Re: **PETITION NO. 1455** - The Connecticut Light and Power Company d/b/a Eversource Energy petition for a declaratory ruling, pursuant to Connecticut General Statutes §4-176 and §16-50k, for the proposed 1588 Line Rebuild Project, consisting of the replacement and reconductoring of electric transmission line structures along approximately 2.65 miles of its existing 115-kilovolt (kV) electric transmission line within existing Eversource transmission line right-of-way (ROW) that extends from Wallingford Electric's Colony Substation, located at 15 Old Colony Road, Wallingford and Wallingford Electric's North Wallingford Substation, located at 130 Thorpe Avenue, Wallingford, Connecticut, and related electric transmission line structure improvements.

Attachment: Updated Map-Sheet 2

Eversource ENERGY						
1588 Line Rebuild Project						
Wallingford						
Map Sheet 2 of 5						
March, 2021						
NO.	DATE	REVISIONS	BY	CHK	APP	APP

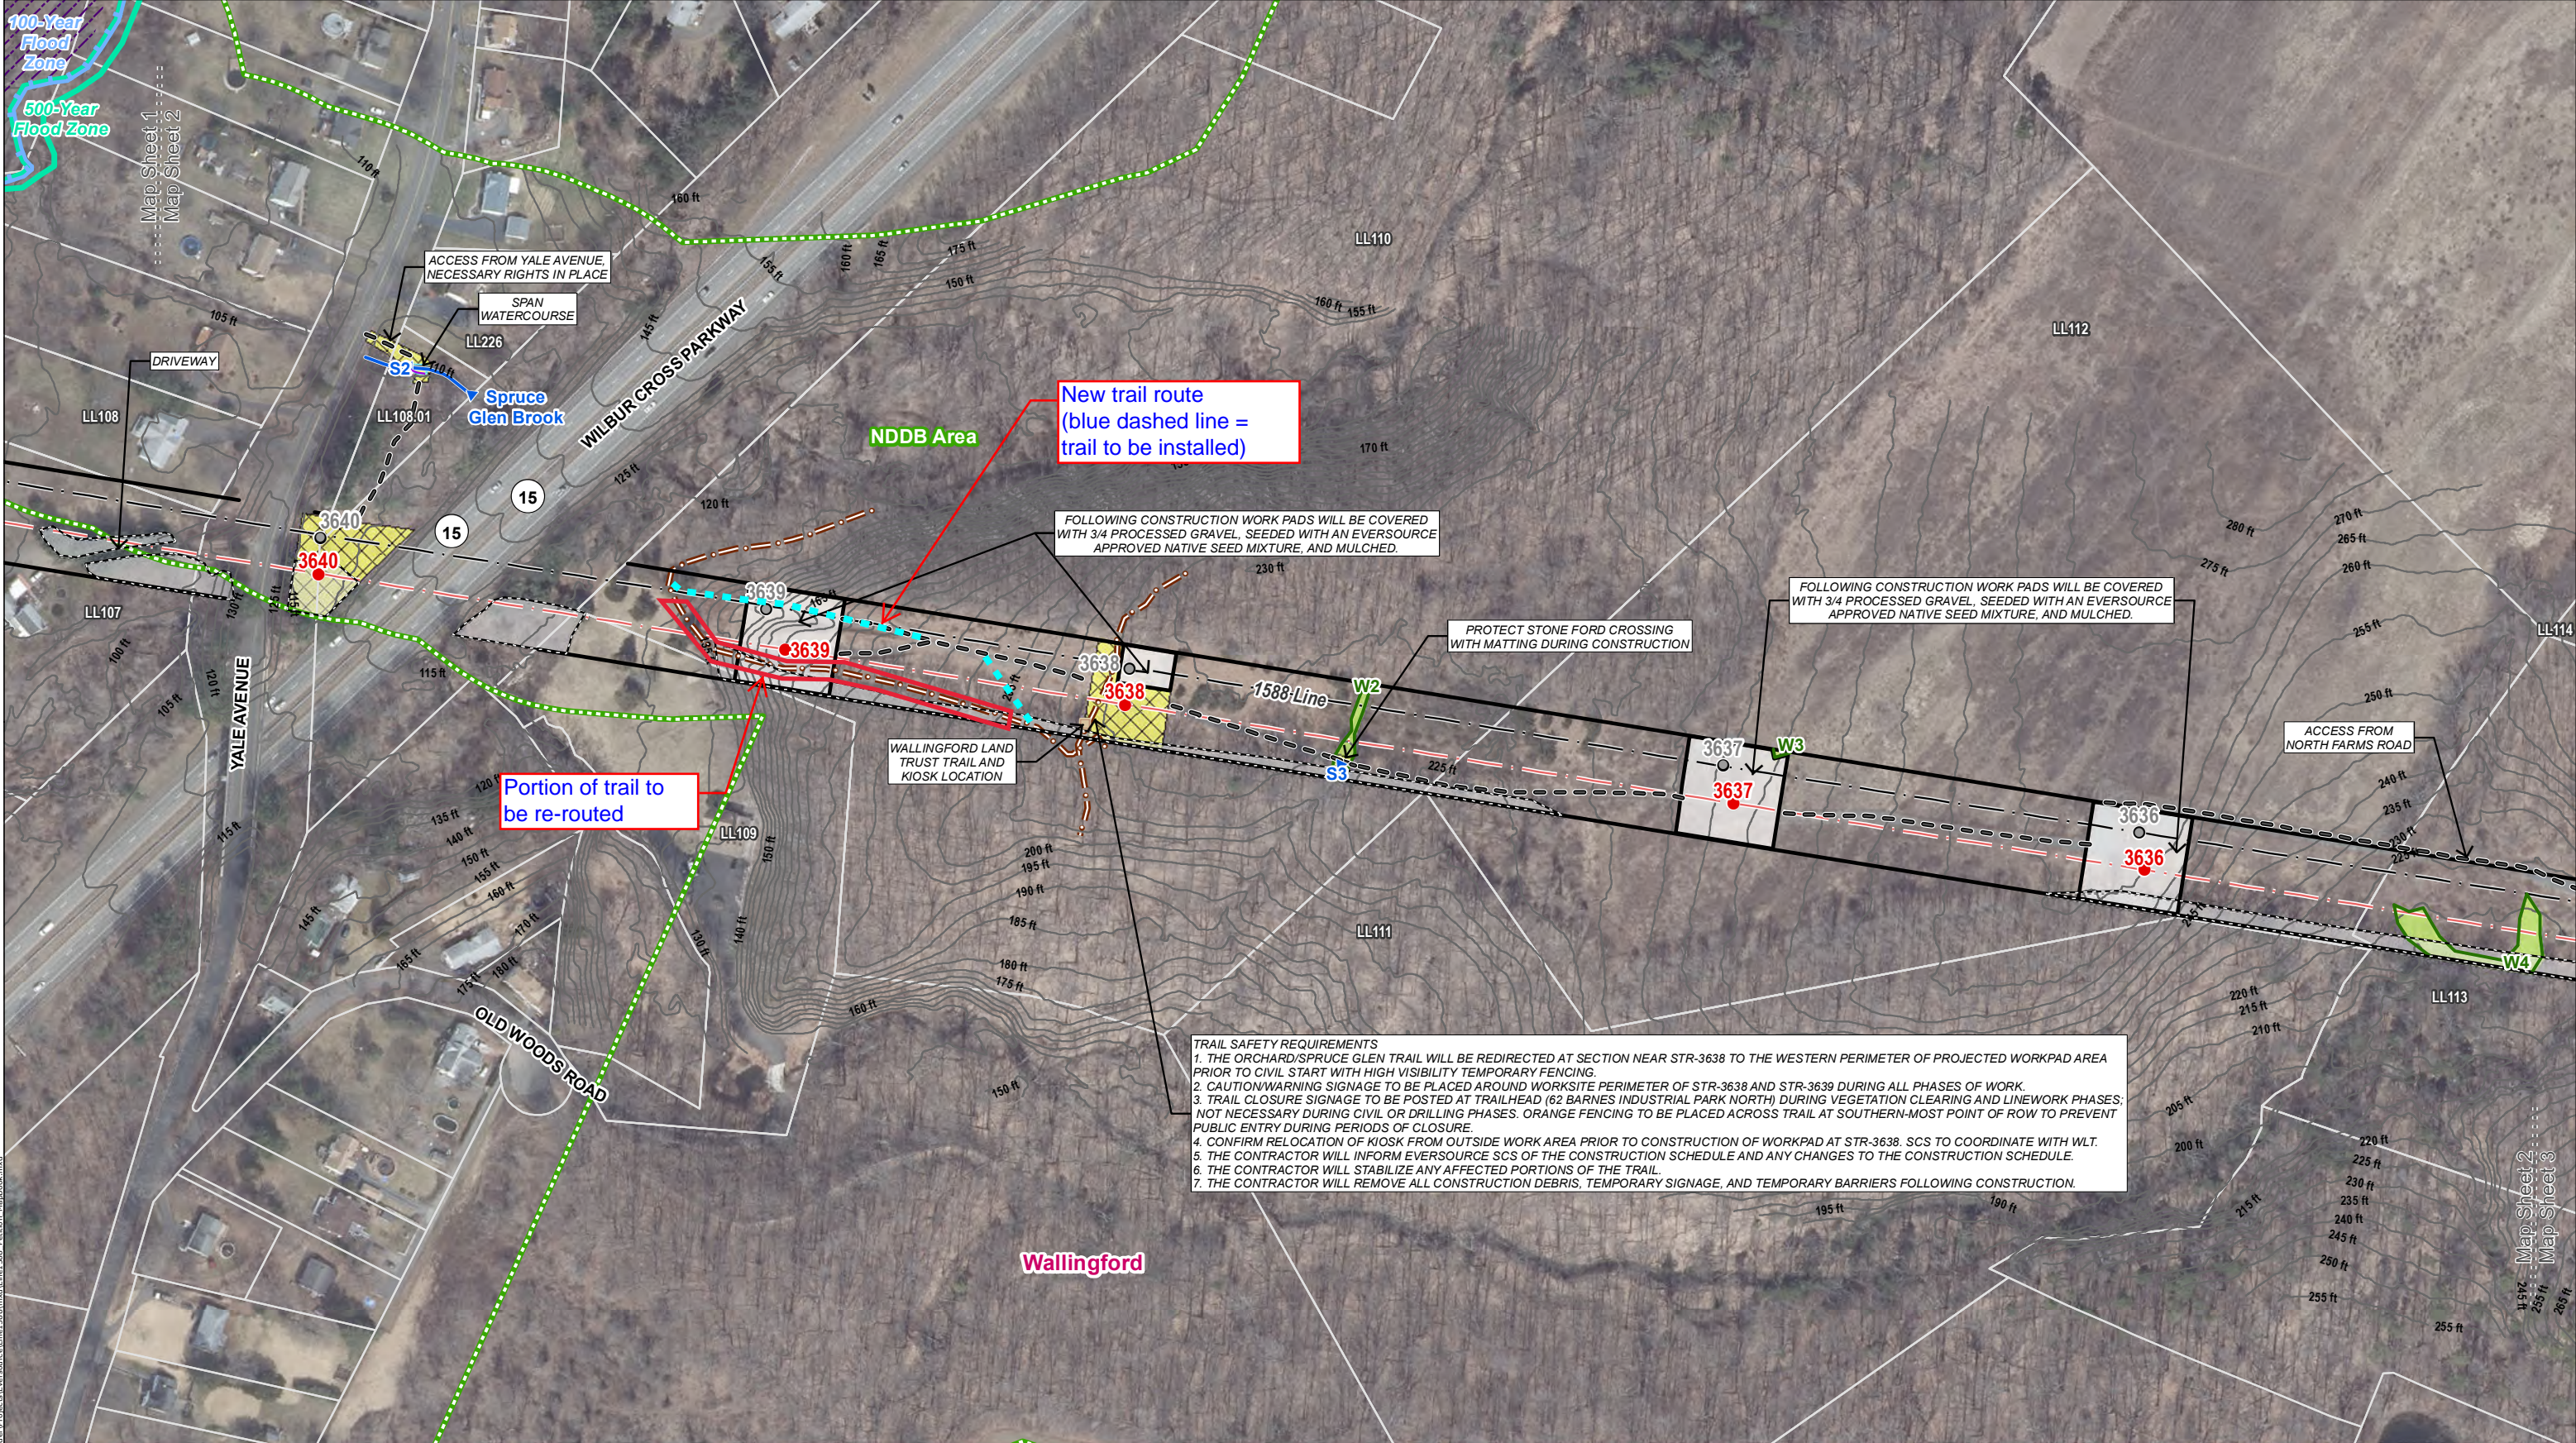
Eversource Petition 1455 was approved by the Council June 18, 2021 and is in construction. Due to constructability constraints the work pad for Structure 3639 needed a more robust work pad to be stabilized with riprap, in order to fight erosion and downhill sediment. The robust work pad requires a re-routing of the Orchard Spruce Glen Trail. Eversource has been working closely with the Wallingford Land Trust. With the help of the Land Trust, a new route moving the Trail closer to the old structure was mapped out (see attached new Map-Sheet 2).
